**Additions and Renovations  
Platt Technical High School  
Milford, CT**

**ADDENDUM NO. 2**

July 29, 2019

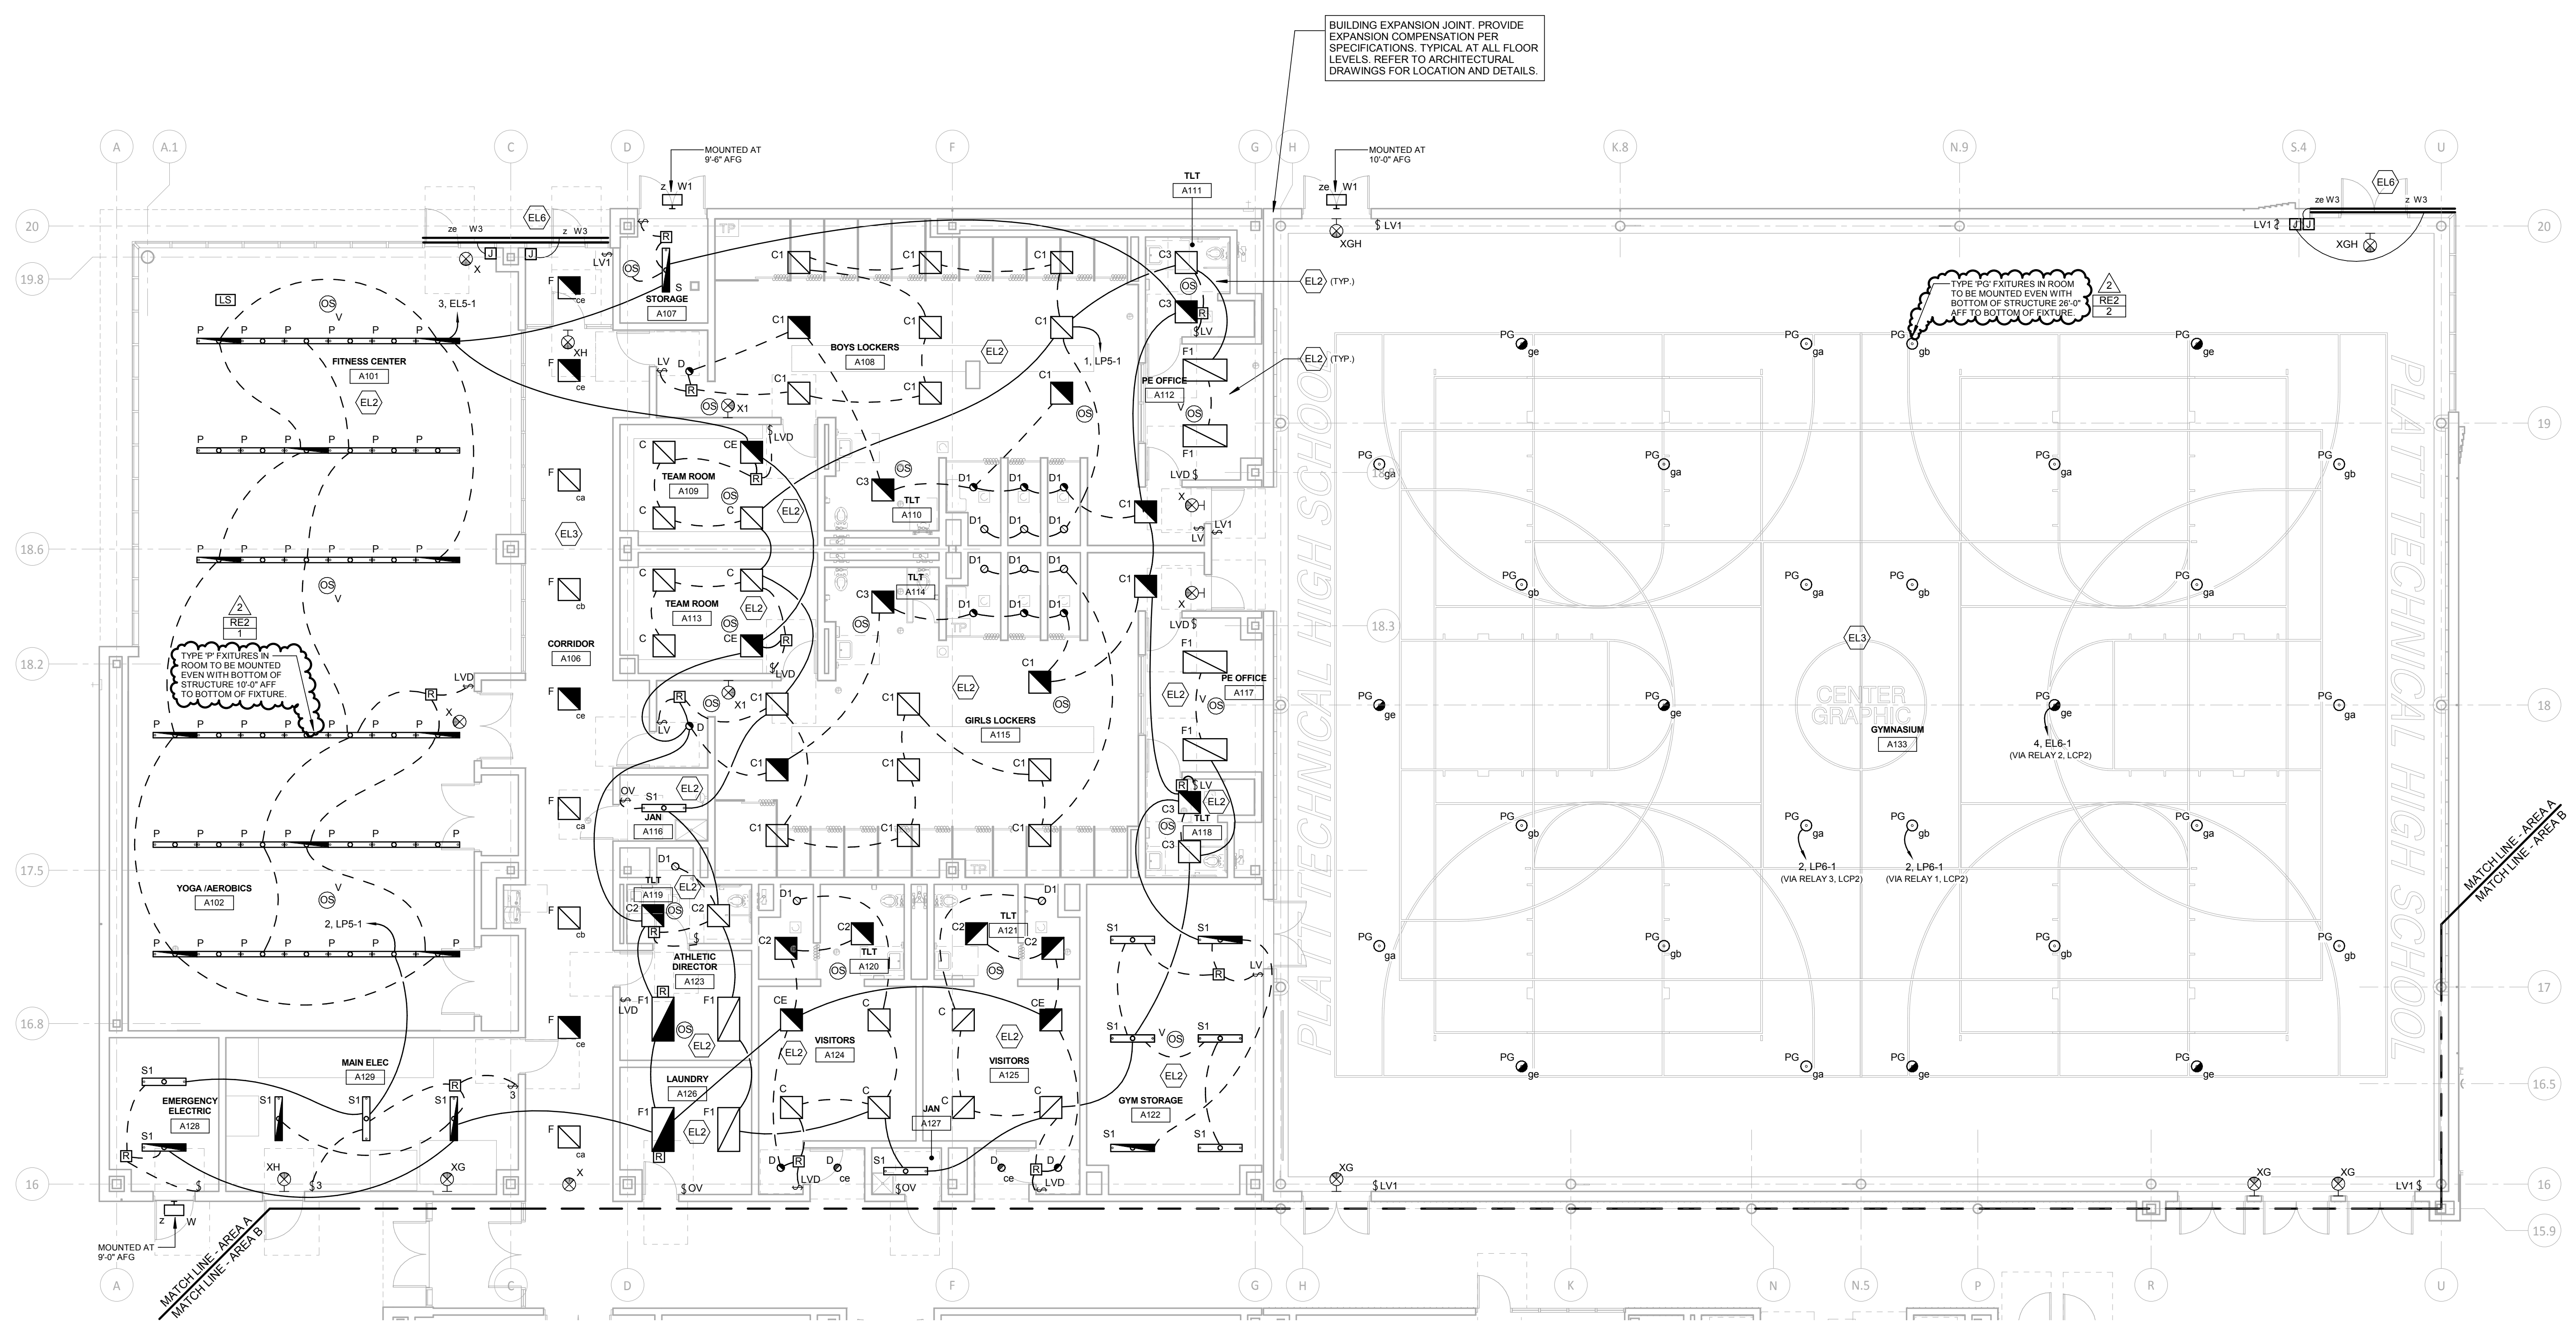
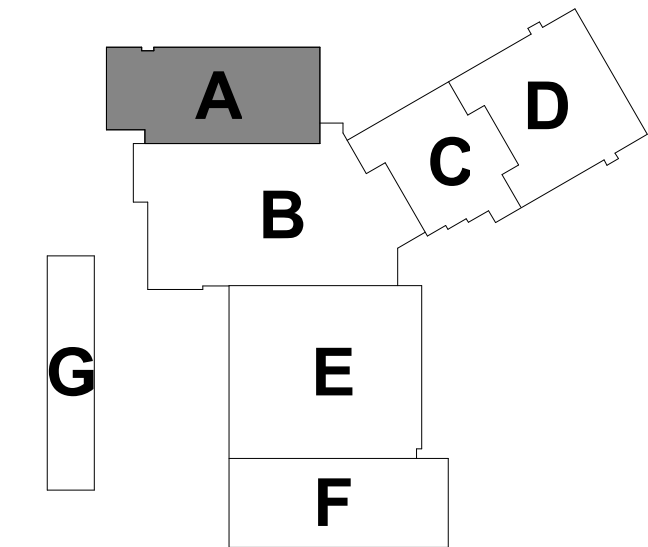
- ADD 2-038      DRAWING E1-1-1A – FIRST FLOOR ELECTRICAL LIGHTING PLAN AREA A**  
Added callout for mounting height of pendant fixtures in Fitness Center A101 per Revision RE2-1.  
Added callout for mounting height of pendant fixtures in Gymnasium A133 per Revision RE2-2.

1 FIRST FLOOR LIGHTING PLAN - AREA B  
1/8" = 1'-0"

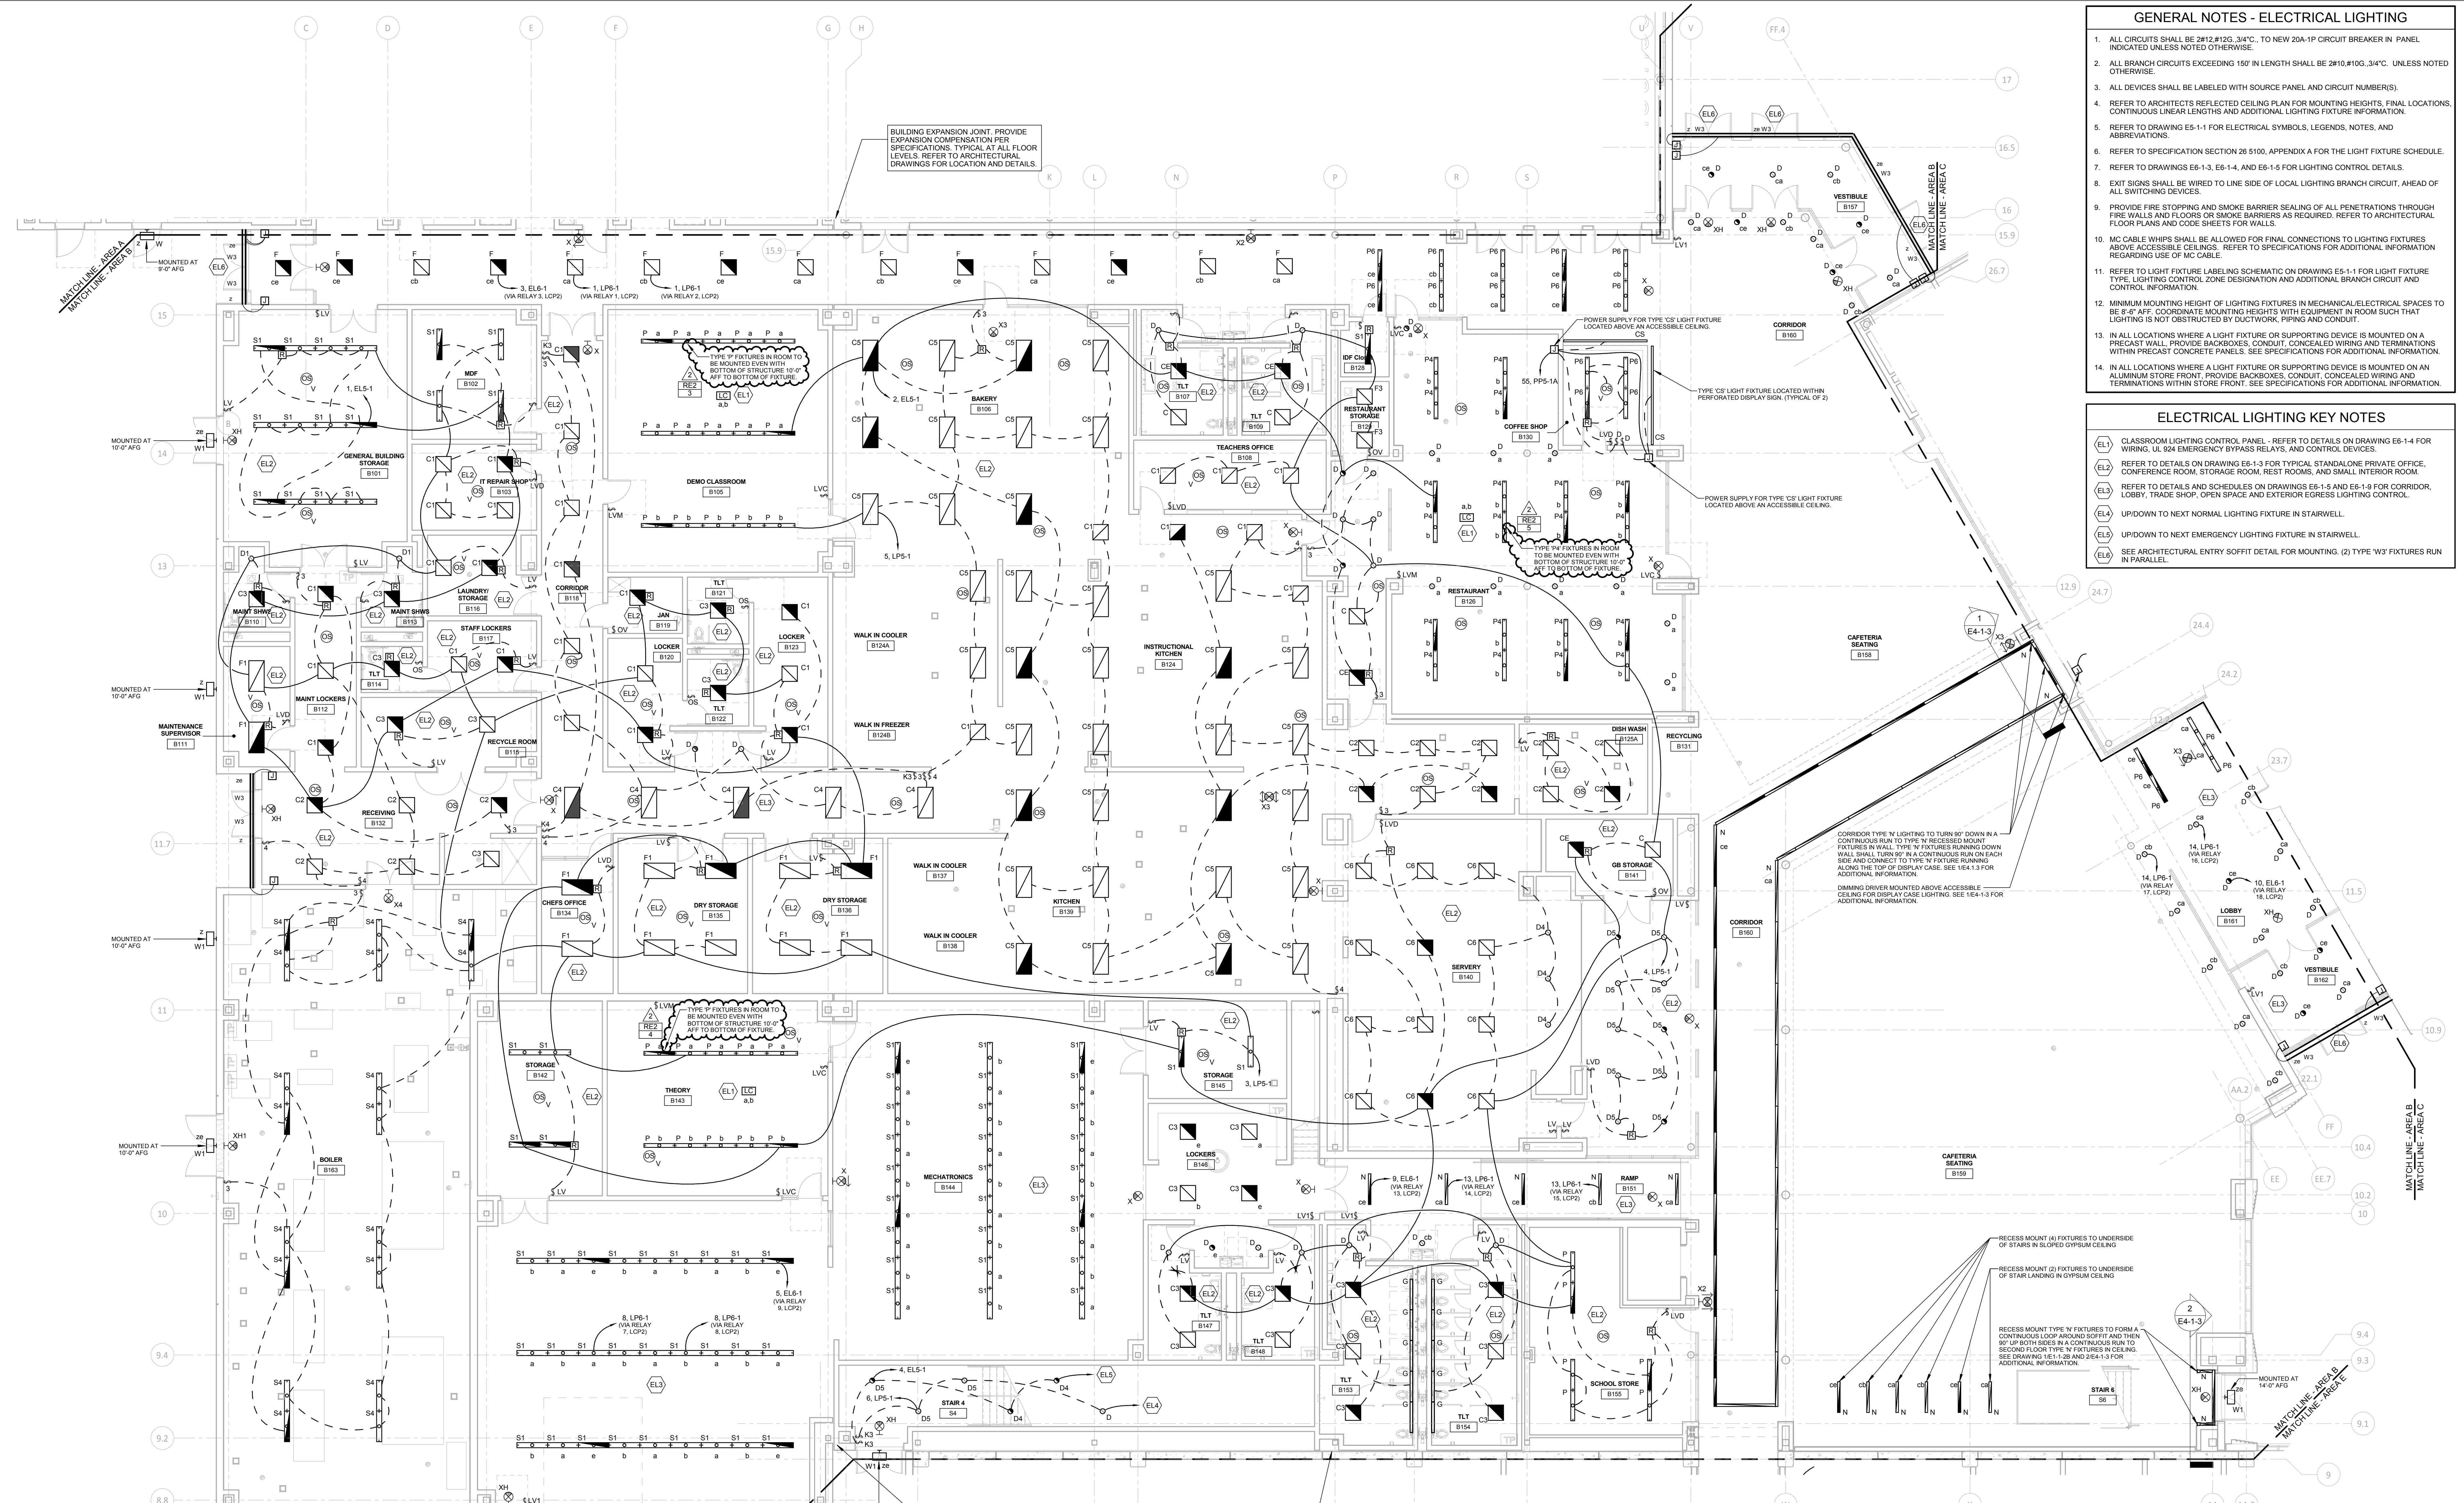
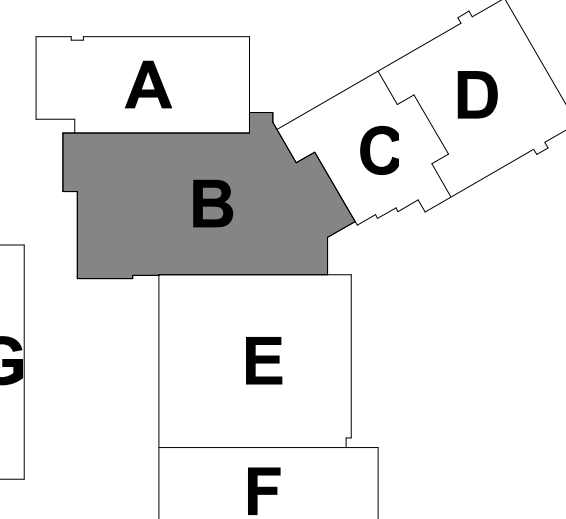
- ADD 2-039      DRAWING E1-1-1B – FIRST FLOOR ELECTRICAL LIGHTING PLAN AREA B**  
Added callout for mounting height of pendant fixtures in Demo Classroom B105 per Revision RE2-3.  
Added callout for mounting height of pendant fixtures in Theory B143 per Revision RE2-4.  
Added callout for mounting height of pendant fixtures in Restaurant A126 per Revision RE2-5.
